**Rezoning from “Residential (Group D)” to “Residential (Group C) 1” Zone  
For a Proposed Residential Development  
at Various Lots in D.D. 104 and the Adjoining Government Land  
in Yuen Long, N.T.  
- S12A Amendment of Plan Application -  
(Planning Application No: Y/YL-MP/10)**

**Further Information No. 1**

## **Response-to-Comment Table**

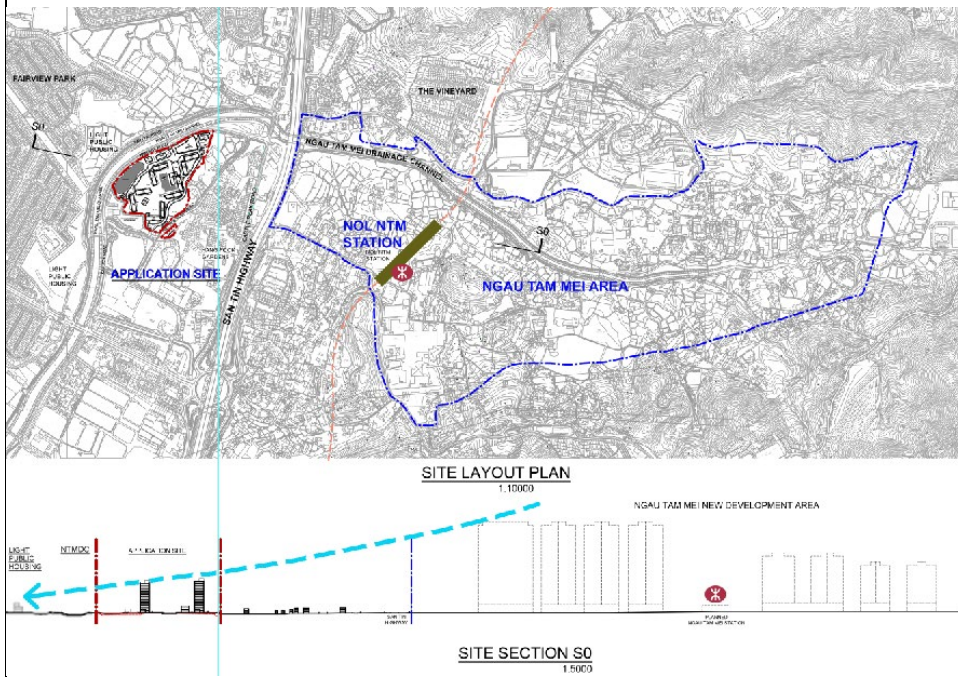
<p><b><u>Comments from Highways Department:</u></b> <b>(Contact Person: Ms W Y YEUNG Tel: 2762 4928)</b></p> <p>The applicant shall provide an implementation programme and a Construction Traffic Impact Assessment (CTIA) report for consideration.</p>	<p>Please refer to para. 5.1.15 of the revised Traffic Impact Assessment in <i>Appendix VII</i>.</p>
<p><b><u>Comments from Architectural Services Department:</u></b> <b>(Contact Person: Ms Jacqui CHEUNG Tel: 2582 5322)</b></p> <p>The proposed building height (BH) of 16 storeys (59.85mPD) is much higher than the BHs of the existing development immediately adjacent to the application site. The proposed BH appears to be incompatible with</p>	<p>The Applicant is in line with the Hong Kong Housing Policy 2021 to tackle the city’s acute housing crisis by building a “Northern Metropolis” along its border with Mainland China, the development will cover ‘mature</p>

Comments	Response
the BHs of the existing adjacent developments as stipulated in the current Outline Zoning Plan.	<p>new towns’ including Tin Shui Wai, Yuen Long, Fanling and Sheung Shui.</p> <p>The Applicant has already been incorporated some design and mitigation measures to promote visual permeability and interest including stepped building height profile descending from east to the west toward the existing Ngau Tau Mei Channel and yet integrating the character of the surrounding site by proposing the landscape pond at the western side of the proposed development which considered compatible to adjacent area.</p> <p>The illustrations are indicated below showing the mitigation and interest with the stepped height profile descending from east to west.</p>
